**CHARTER TOWNSHIP OF BRIGHTON
PLANNING COMMISSION
4363 BUNO ROAD
BRIGHTON, MI 48114**

**NOVEMBER 10, 2025
REGULAR MEETING
6:30 P.M.
(810) 229.0562**

- 1. RE-REVIEW OF PUD REZONING RZ #25/01 FOR THE COVE AT WOODLAND LAKE;
ADDRESS: VACANT DANN/N. CHRISTINE; OWNER AND APPLICANT: MITCH
HARRIS BUILDING COMPANY; TAX ID#: 12-18-300-011 AND 12-18-400-027; EXISTING
ZONING: R-2 (RESIDENTIAL SINGLE FAMILY); PROPOSED ZONING:
RESIDENTIAL PLANNED UNIT DEVELOPMENT (PUD)**

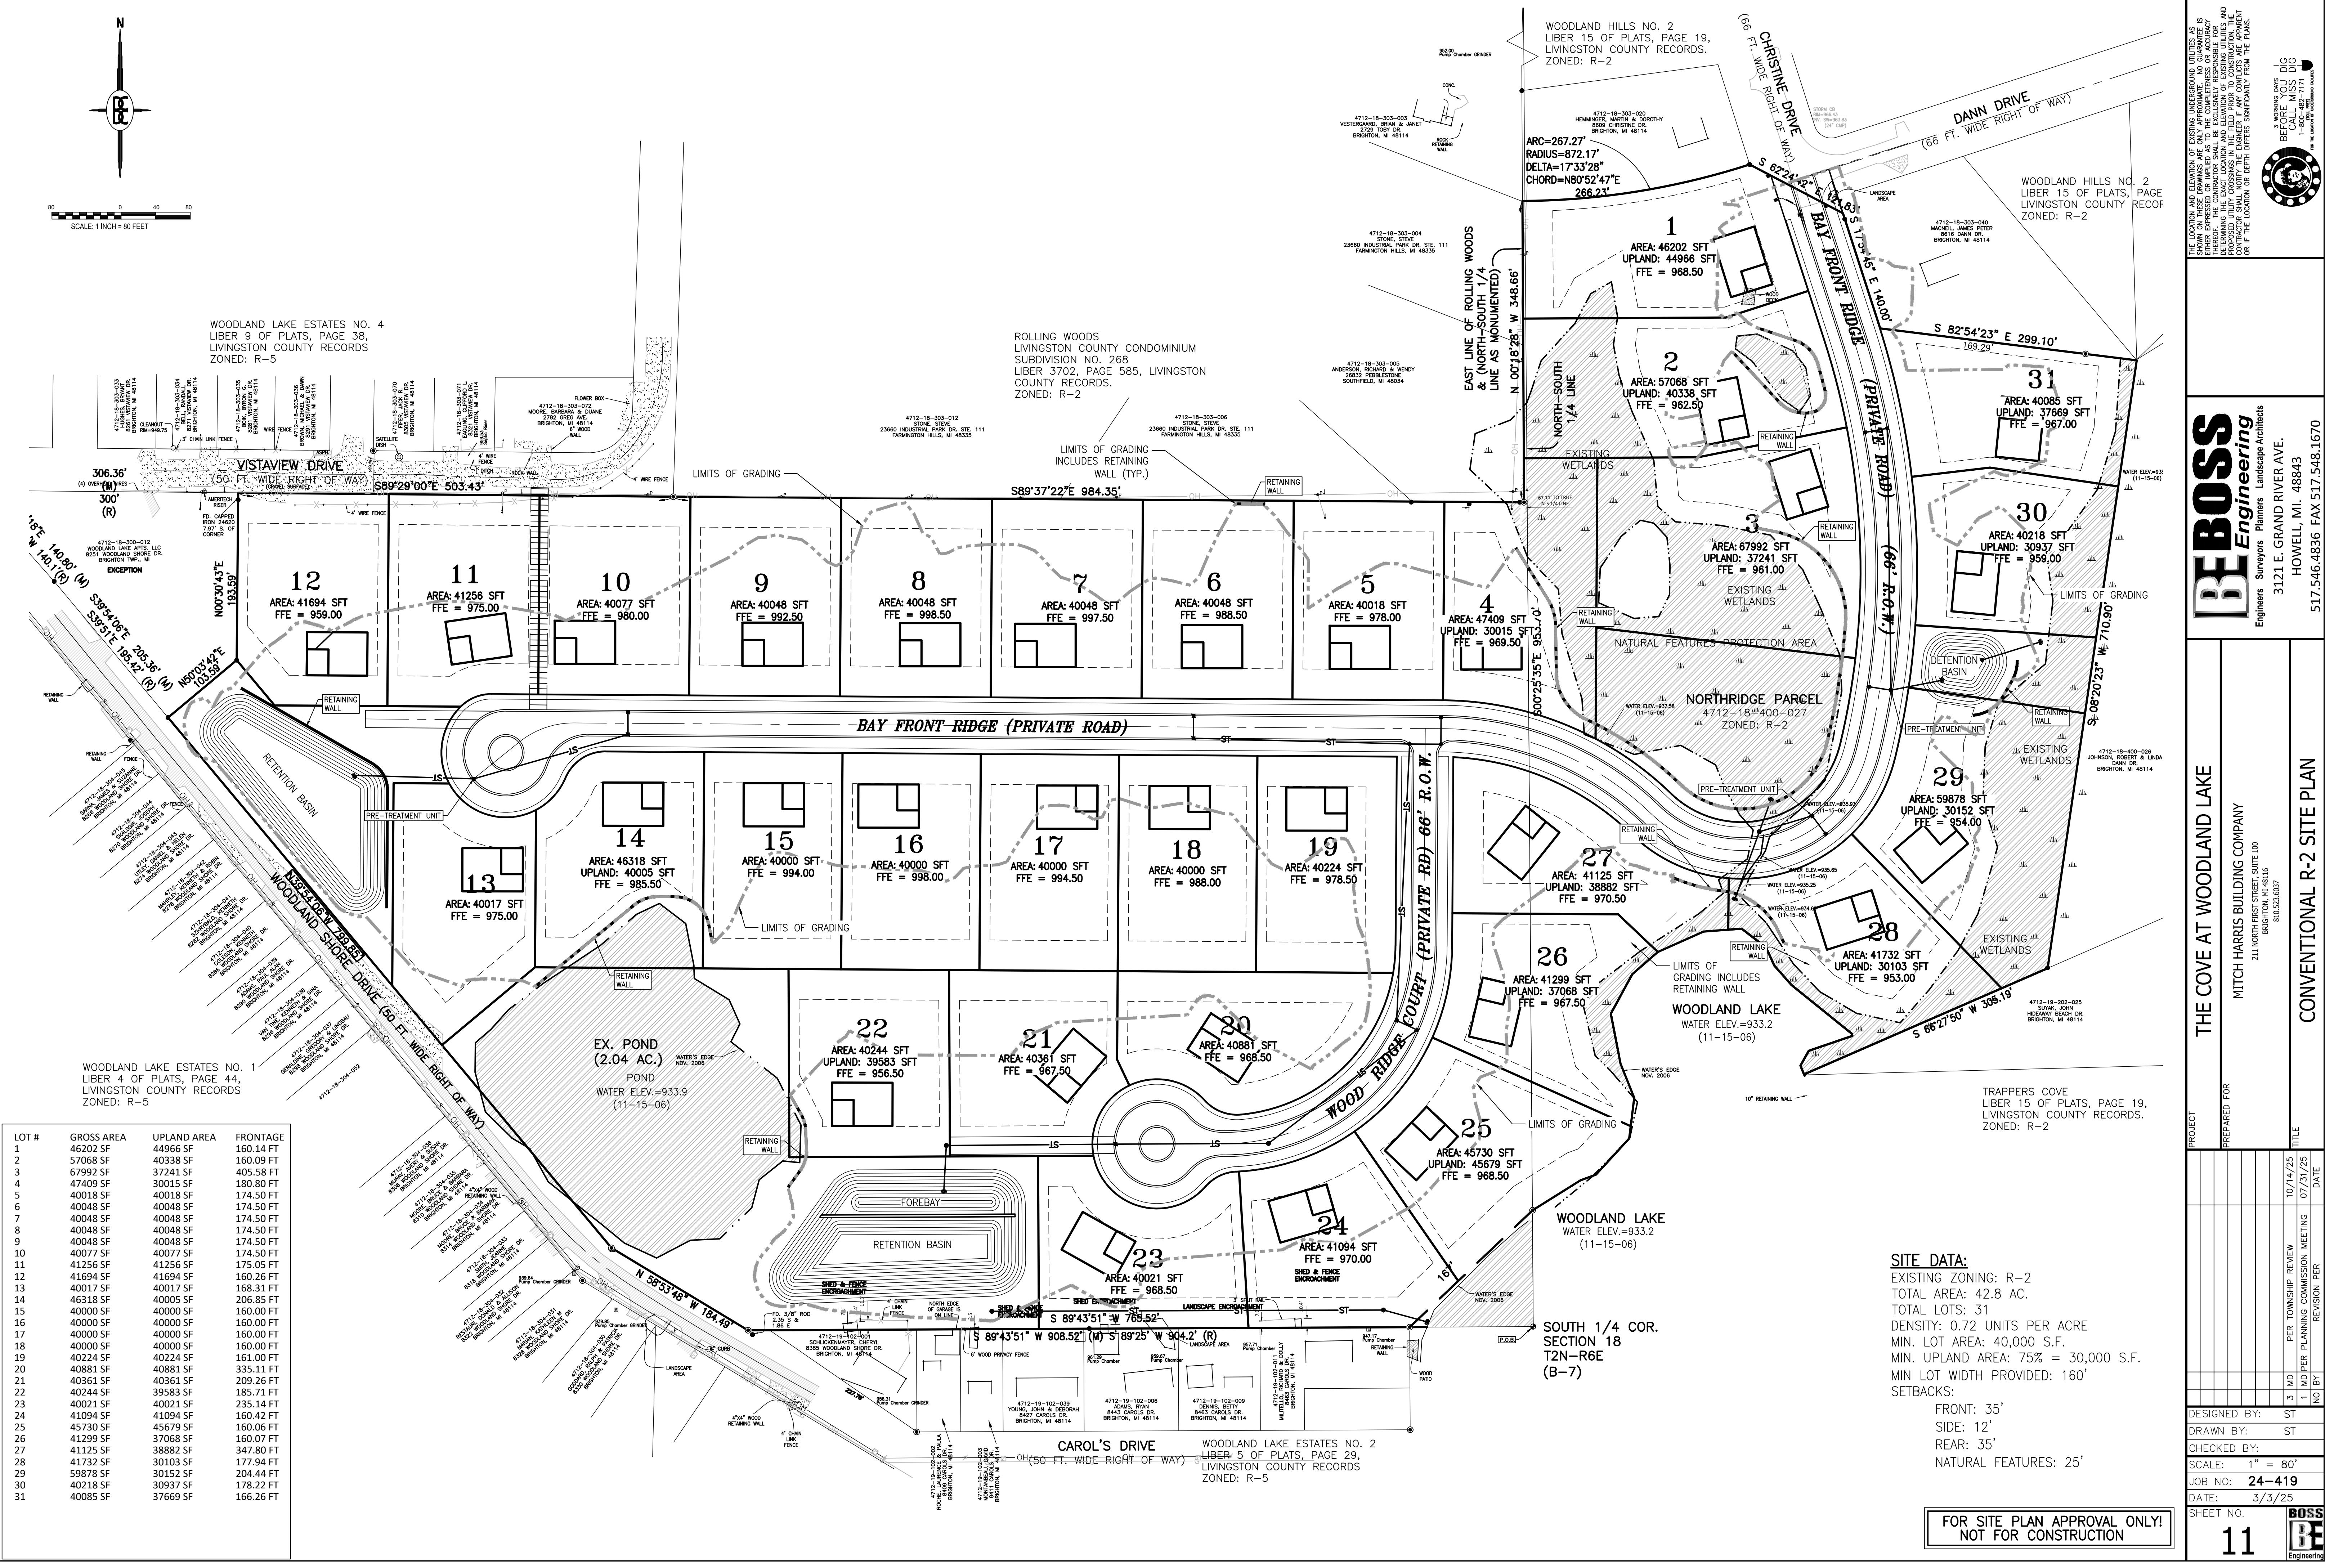
5. The proposed storm sewer and its corresponding inverts connecting Forebay B to the Retention Basin is recommended to be shown in the Retention Basin Cross Section on Sheet 10 for clarification of how this system will function. The depiction of Forebay B's spillway into the Retention Basin should also be revised as this forebay is proposed to overflow into the existing pond.
